Addendum

New Glasgow Public Library & PARL Headquarters Revitalization

| 16 April 2024 | 23-053         | 04         |

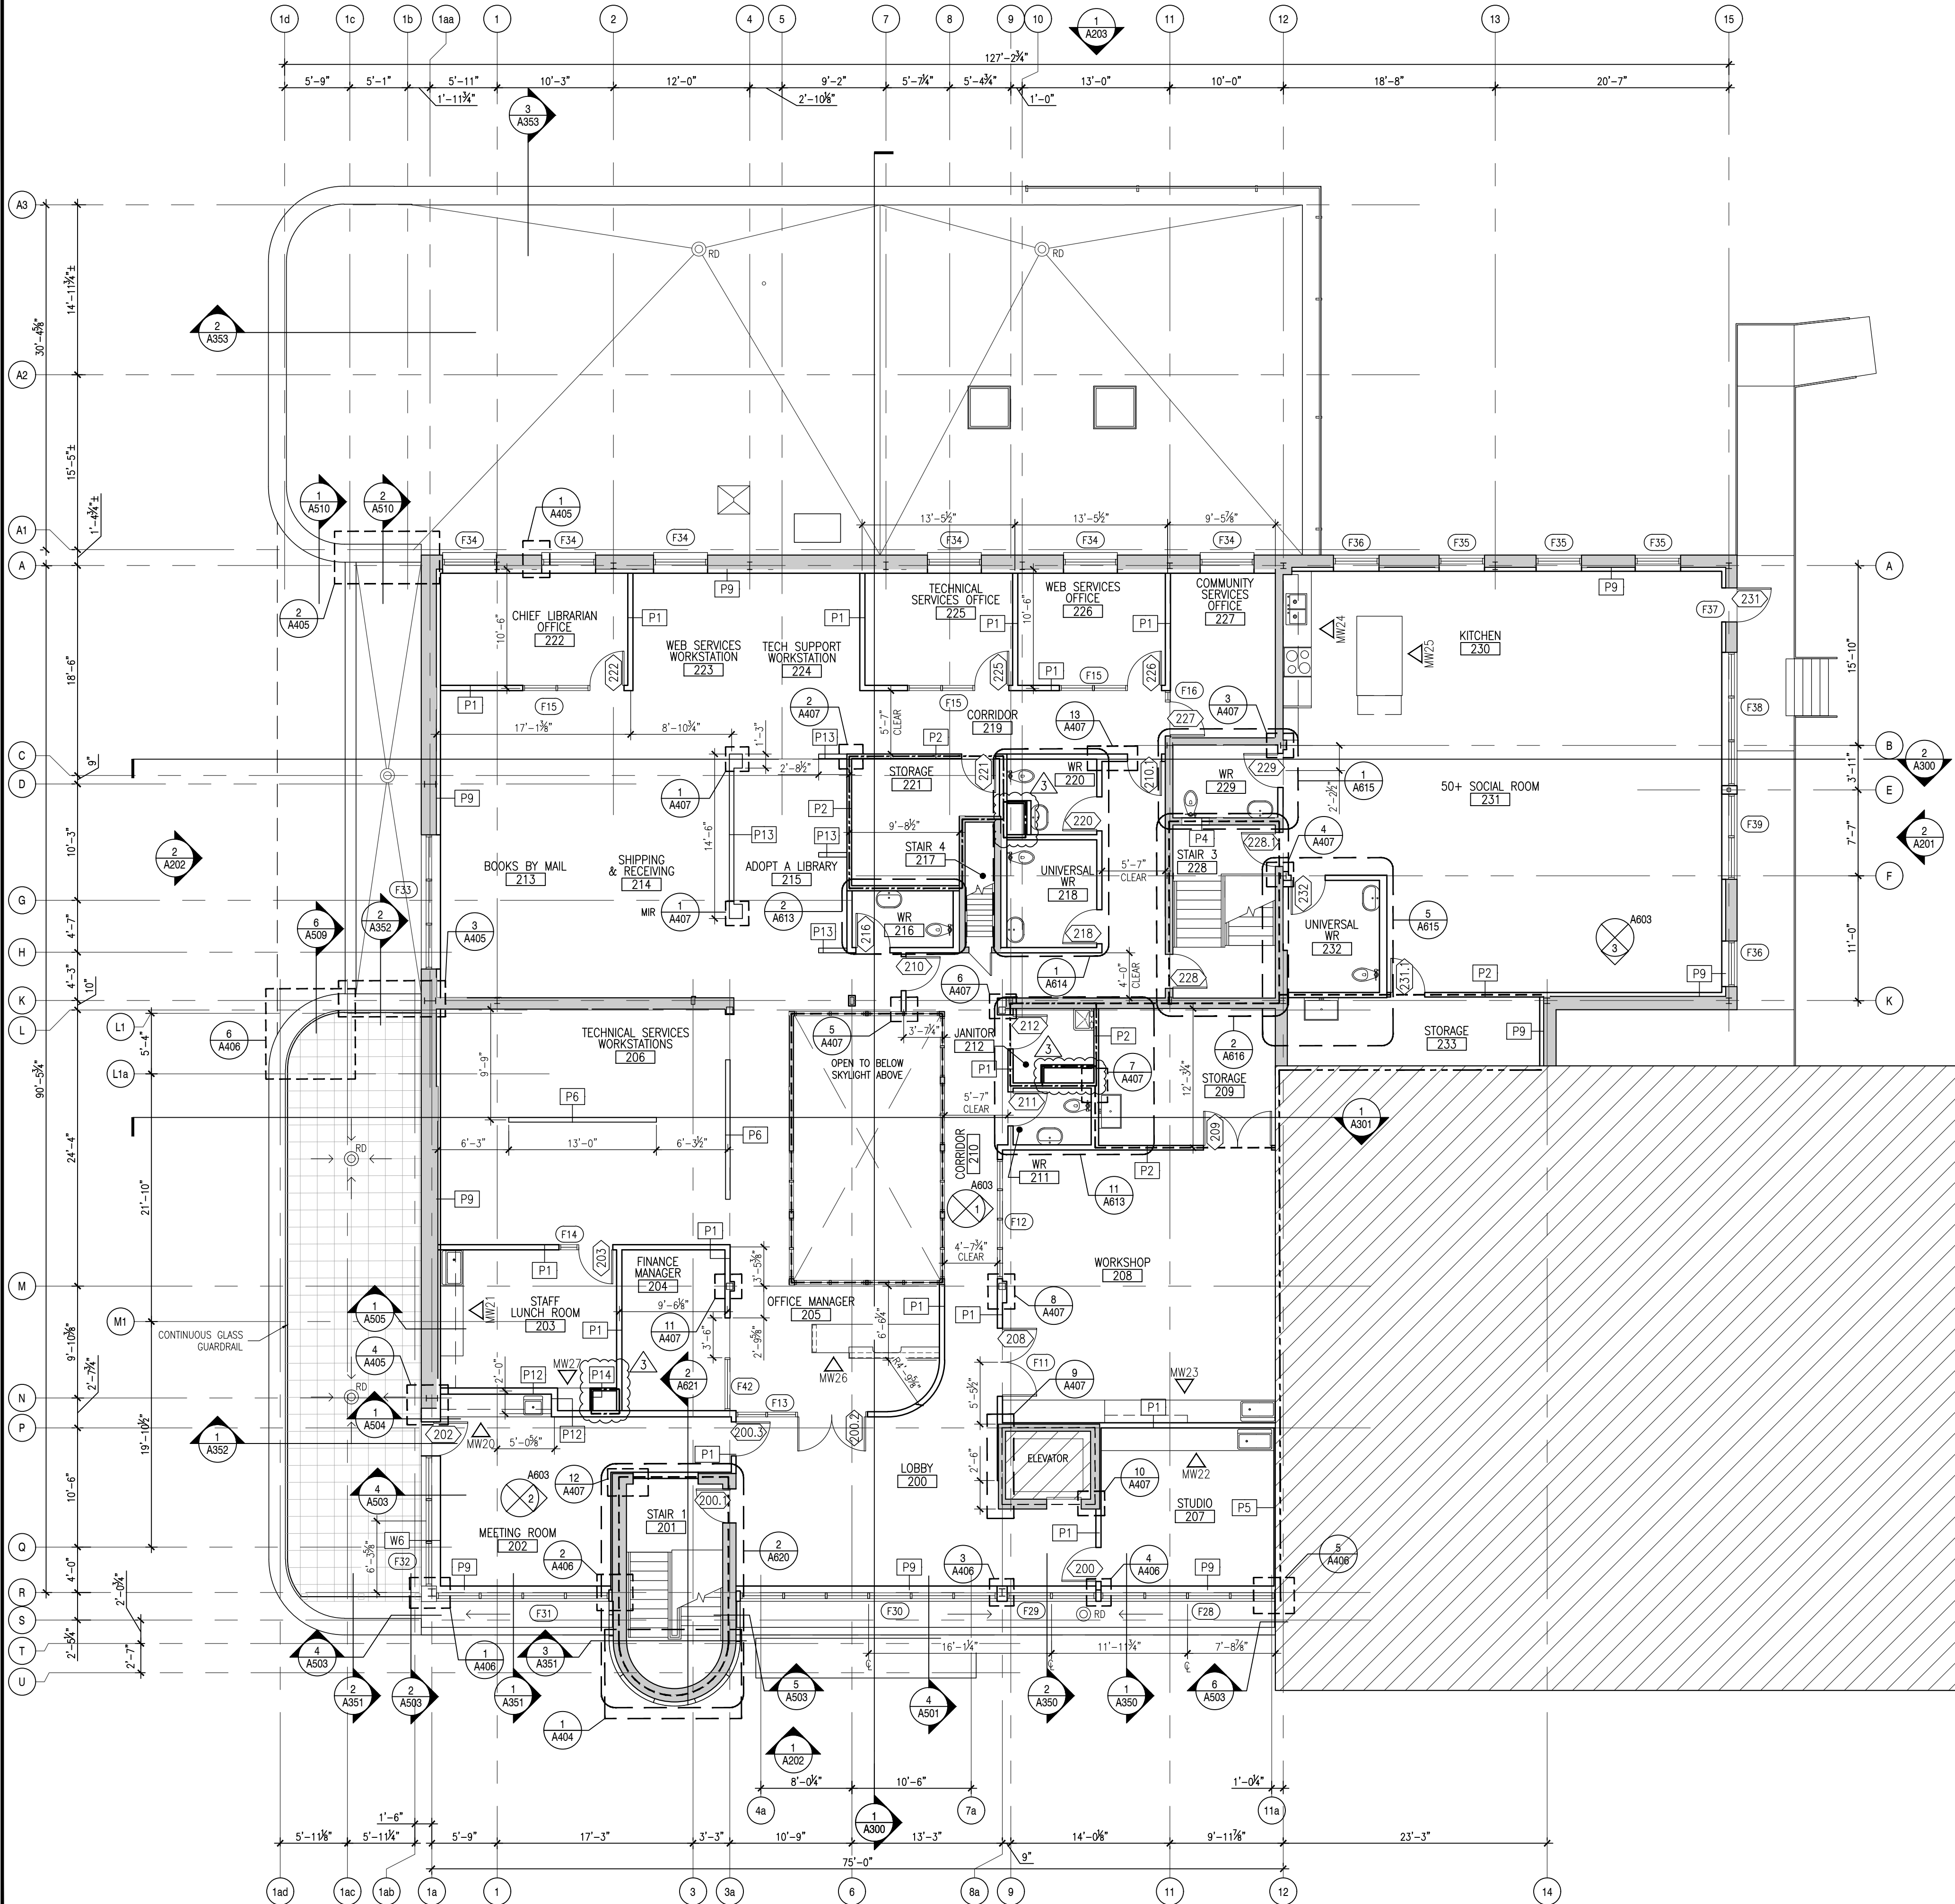
- 2.1 Replace Drawing A106 Level 2 Floor Plan: Revise fire rating and assembly of mechanical shafts.
- 2.2 Replace Drawing A402 and A403 Plan Details: Additional dimensioning for lighting.
- 2.3 Replace Drawing A500 Section Details: Additional mechanical louvre in soffit.
- 2.4 Replace Drawing A502 Section Details: Detail 2/A504 - Additional non-shrink grout under sill and sealant at curtain wall entrance.
- 2.5 Replace Drawing A503 Section Details: Detail 2/A504 and 3/A504 - Additional water-proofing and flashing at guardrail standoff.
- 2.6 Replace Drawing A504 Section Details: Detail 2/A502 and 3/A502 - Additional non-shrink grout and steel angle under sill.
